CITY OF PORTLAND

City of Portland, Maine - Building or Use Permit Application

Proposed Project Description:
New Single Family Home- w/ 2 Car garage

ONE AND TWO FAMILY	PLAN REVIEW	CHECKLIST
Soil type/Presumptive Load Value (Table R401.4.1)		
STRUCTURAL		
④ Footing Dimensions/Depth (Table R403.1 & R403.1(1), (Section R403.1 & R403.1.4.1)	Notes - not large enough	Pg 2 + SA - OK
Foundation Drainage, Fabric, Damp proofing (Section R405 & R406)	Hand noted on sheet #2	
Ventilation/Access (Section R408.1 & R408.3) Crawls Space ONLY	N/A	
⑤ Anchor Bolts/Straps, spacing (Section R403.1.6)	not shown	Pg 2 - OK
Lally Column Type (Section R407)		
Girder & Header Spans (Table R 502.5(2))	3-2x10's - 5'-4" Max span - OK	
Built-Up Wood Center Girder Dimension/Type	" "	
③ Sill/Band Joist Type & Dimensions	not shown	Pg 5A - OK
First Floor Joist Species Dimensions and Spacing (Table R502.3.1(1) & Table R502.3.1(2))	2x10's - OK	
Second Floor Joist Species Dimensions and Spacing (Table R502.3.1(1) & Table R502.3.1(2))	2x10's - OK	
Attic or additional Floor Joist Species Dimensions and Spacing (Table R802.4(1) and R802.4(2))	2x8's - OK

LOT 6 - GRADING PLAN
 AUTUMN GLEN SUBDIVISION

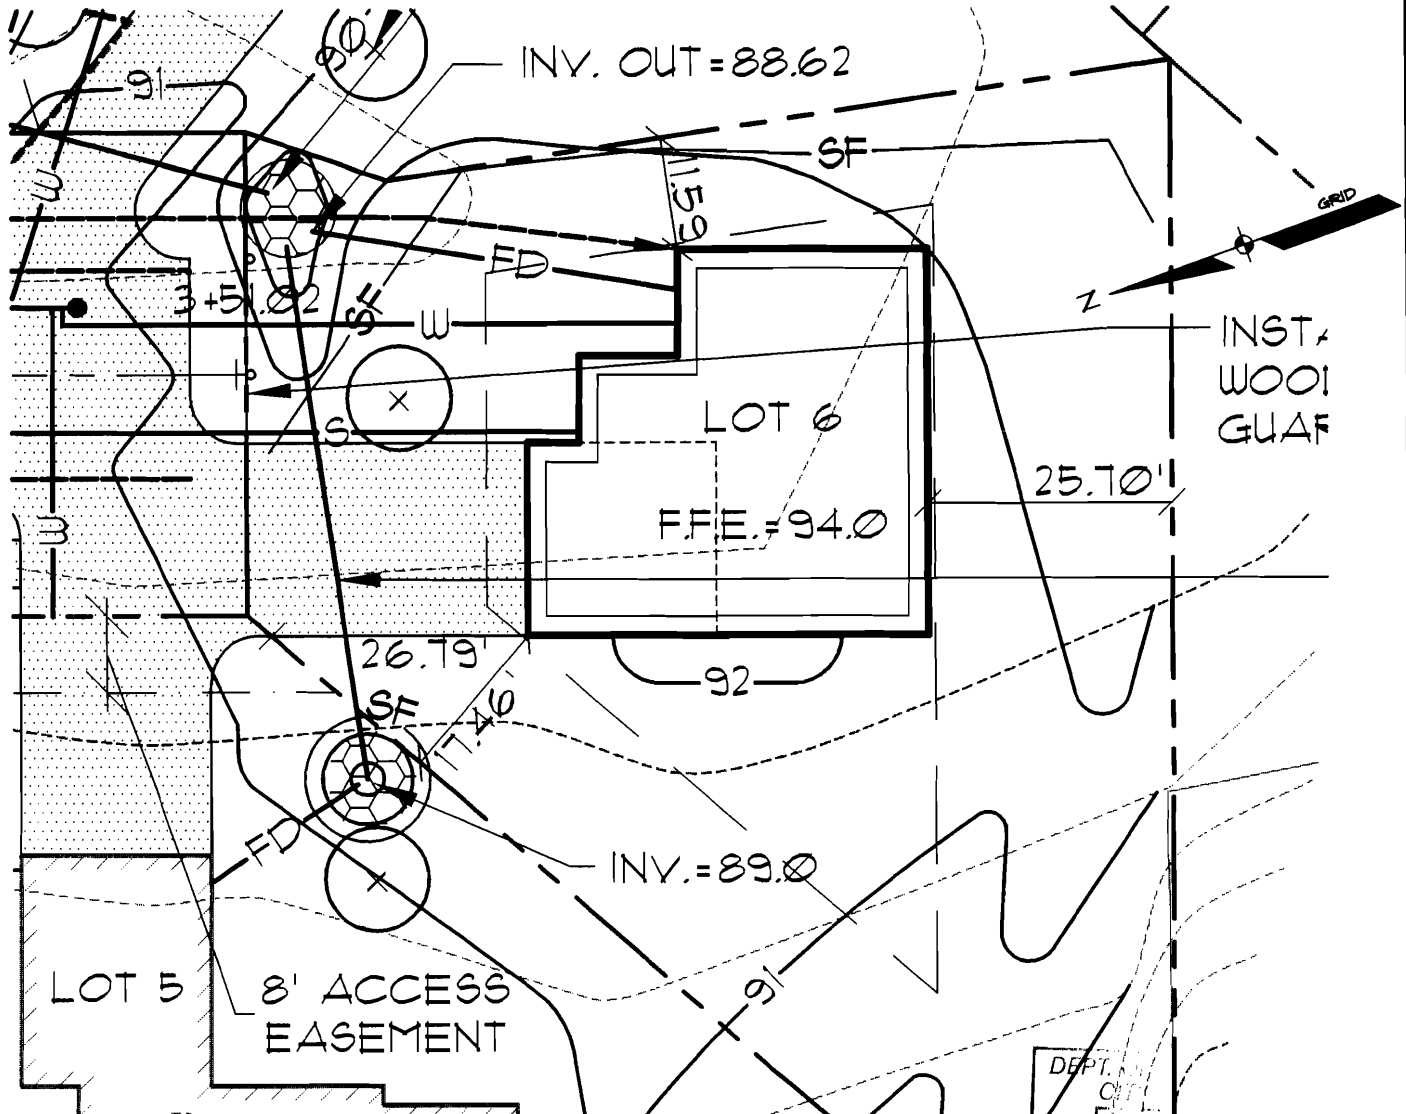
10/4/2006-amachado: Left message for King Weinstein to call me. Front setback is not met. Scales at 24.5' not the required 25' and the elevationn plans show a daylight basement in the back, but the grading plan does not match this.

10/6/2006-amachado: Received revised site plan. Meets zoning requirements. Still waiting for correct elevation plans.

3 TYP. CORNICE DETAIL
3/4" = 1'-0"

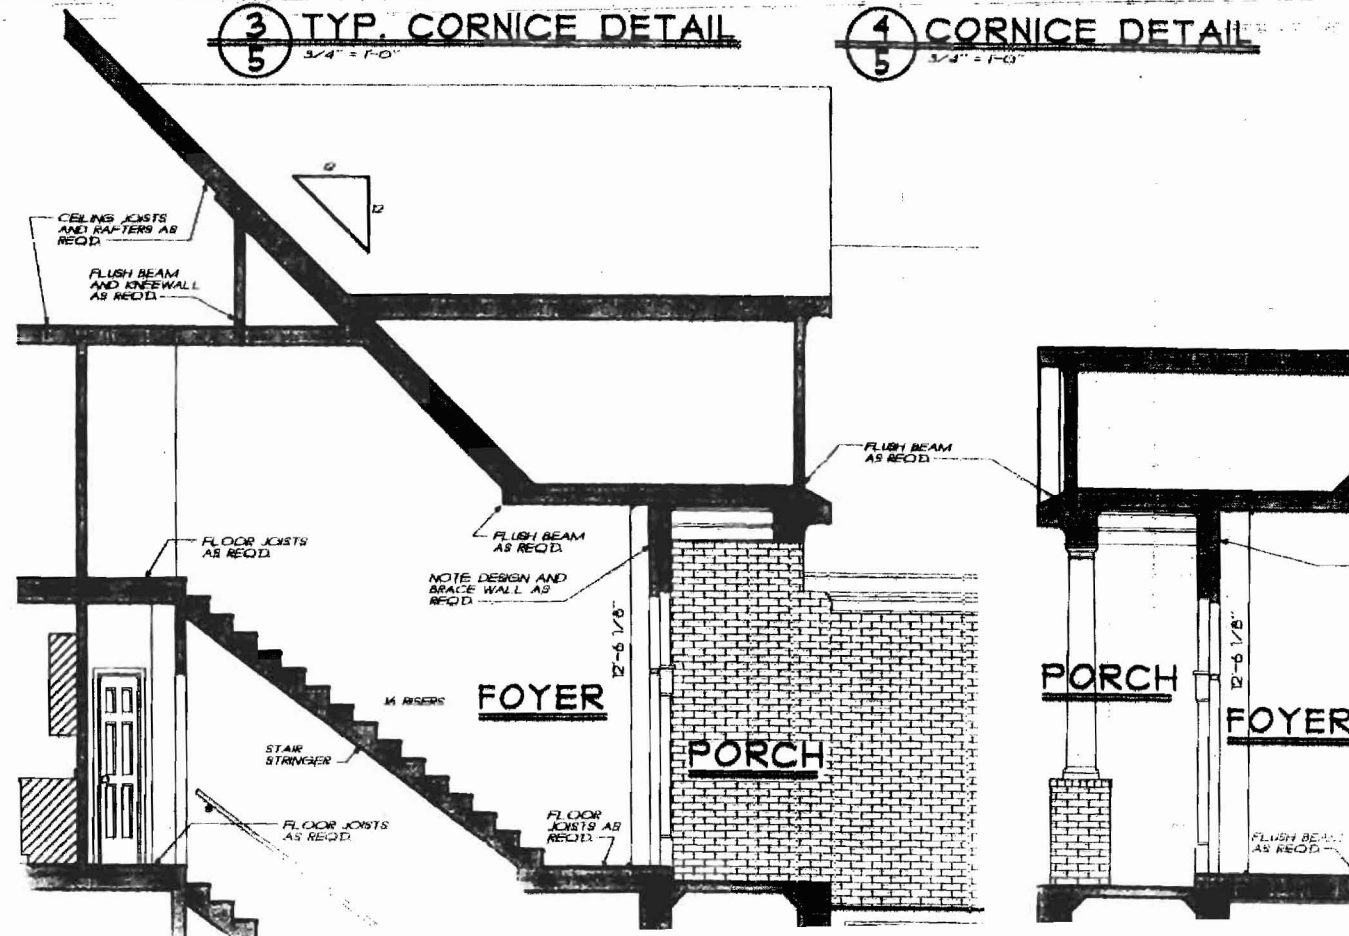
<p>(4) Pitch, Span, Spacing & Dimension (Table R802.5.1(1) - R802.5.1(8)) Roof Rafter; Framing & Connections (Section R802.3 & R802.3.1)</p>	<p>Rafters - undersized + is there a beam under "splice" point.</p>	<p>REF Print #5 3/4" Detail 4/5</p>
<p>(3) Sheathing; Floor, Wall and roof (Table R503.2.1.1(1))</p>	<p>5/8" Roof 1/2" - Floors? walls 3/4" 3/4"</p>	
<p>Fastener Schedule (Table R602.3(1) & (2))</p>	<p>Per IRC</p>	
<p>Private Garage (Section R309) Living Space? - YES (Above or beside) Fire separation (Section R309.2) Opening Protection (Section R309.1)</p>	<p>Hand noted on sheet 3 - 5/8" F.C. Tyvek - all surfaces w/ fire door</p>	
<p>(4) Emergency Escape and Rescue Openings (Section R310)</p>	<p>not shown</p>	<p>NOTED ON PRINTS 5:4 (EE)</p>
<p>(4) Roof Covering (Chapter 9)</p>	<p>Asphalt? —</p>	<p>OK</p>
<p>(4) Safety Glazing (Section R308)</p>	<p>Need in master bath</p>	<p>NOTED ON PRINT #4</p>

①	Pitch, Span, Spacing & Dimension (Table R802.5.1(1) - R 802.5.1(8)) Roof Rafter; Framing & Connections (Section R802.3 & R802.3.1)	rafters - undersized + is there a beam under "splice" point.	
②	Sheathing; Floor, Wall and roof (Table R503.2.1.1(1))	5/8" - Roof 1/2" - Floors? walls 3/4"	
	Fastener Schedule (Table R602.3(1) & (2))	Per IRC	
	Private Garage (Section R309) Living Space? - yes (Above or beside) Fire separation (Section R309.2) Opening Protection (Section R309.1)	Hand noted on sheet 3 - 5/8" F.C. Tyrex - all surfaces w/ fire door	
⑥	Emergency Escape and Rescue Openings (Section R310)	not shown	
⑦	Roof Covering (Chapter 9)	Asphalt? - OK	
⑧	Safety Glazing (Section R308)	Need in master bath - OK	
⑨	Attic Access (Section R807)	size? - 2'x6' access panel - OK	
	Chimney Clearances/Fire Blocking (Chap. 10)	N/A	
⑩	Header Schedule (Section 502.5(1) & (2))	not shown	
⑪	Energy Efficiency (N1101.2.1) R-Factors of Walls, Floors, Ceilings, Building Envelope, U-Factor Fenestration	Not shown

- 9) As discussed, the rafters must be 2" x 10"s.
